A d d e n d u m

Iowa Department of Transportation
Office of Contracts

B.O.	Proposal ID	Proposal Work Type	County	Project Number	Addendum
105	18-0032-069	PCC OVERLAY - UNBONDED	CHEROKEE	NHSX-003-2(69)--3H-18	17FEB105.A02

TYPICAL CROSS SECTION AND JOINTING DIAGRAM PCC UNBONDED OVERLAY OVER EXISTING HMA

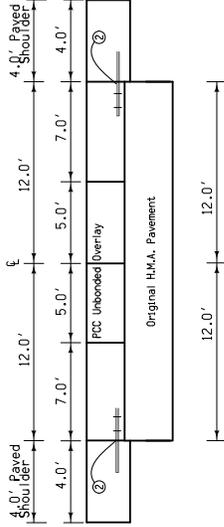
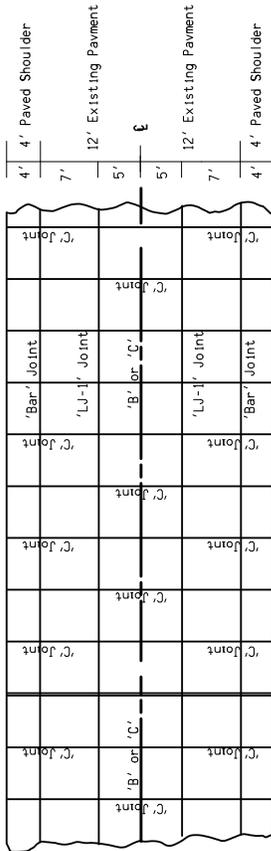
Insert attached plan sheet B.5. in its entirety.

- ① Extend existing expansion joints in kind in new pavement.
- ② Modified "U-1" (M-1) joint #4 Bar at 30" on center spacing with a 3-ft long reinforced bar centered over joint. Maintain minimum 8-in clearance from transverse joints. Minimum 2 staples per Tiebar. Stapling process subject to Engineer approval prior to Paving operation. Approval is based on no tiebar movement during Paving operation.
- ③ See "TIRH-2" on Sheet B.2.

TYPICAL CROSS SECTION AND JOINTING DIAGRAM PCC UNBONDED OVERLAY OVER EXISTING PCC

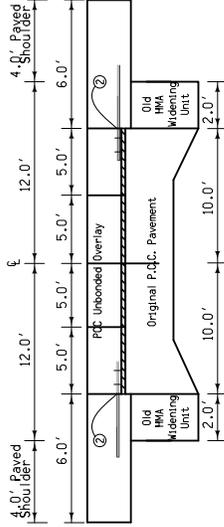
- ① Extend existing expansion joints in kind in new pavement.
- ② Modified "U-1" (M-1) joint #4 Bar at 30" on center spacing with a 5-ft long reinforced bar centered over joint. Maintain minimum 8-in clearance from transverse joints. Minimum 2 staples per Tiebar. Stapling process subject to Engineer approval prior to Paving operation. Approval is based on no tiebar movement during Paving operation.
- ③ See "TIRH-2" on Sheet B.2.
